SECTION A-A

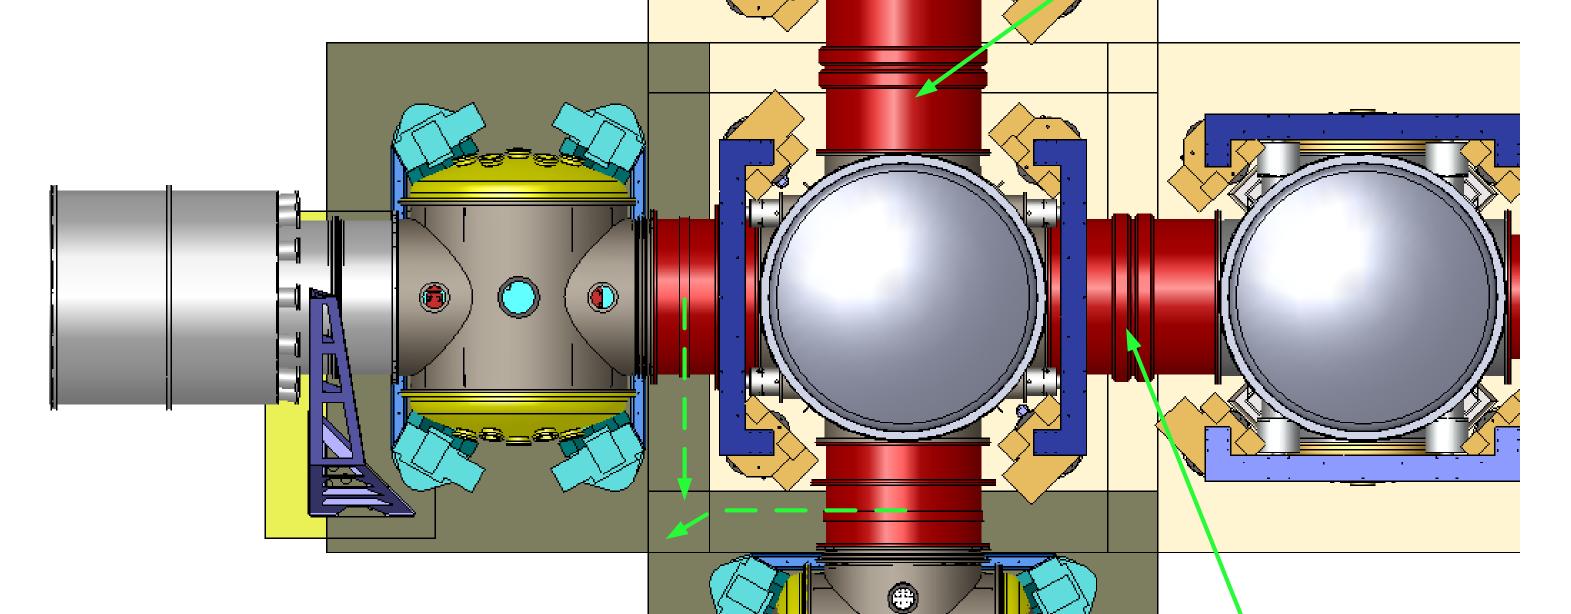
DO WE PROVIDE CABLE TRAYS THAT RING AROUND THE BSC CHAMBERS? OR JUST PASS BY (LIKE RAILS) ON EITHER SIDE OF THE CHAMBER?

LIFT SPLIT (TWO-PIECE) SPOOLS AT TOP CENTER, REMOVE SPOOLS LATERALLY (HORIZONTALLY), THEN UP [NEEDED FOR PRC & SRC INITIAL ALIGNMENT]

SPOOL BETWEEN BSC1 AND BSC2 CAN ONLY BE REMOVED BY LIFTING VERTICALLY
[NEEDED FOR BS OPTIC INITIAL ALIGNMENT]

THE SPOOL BETWEEN BSC3 AND BSC2 IS NOT REMOVABLE (LOCKED IN BY BSC2 CROSSBEAM AND SEI PIERS)
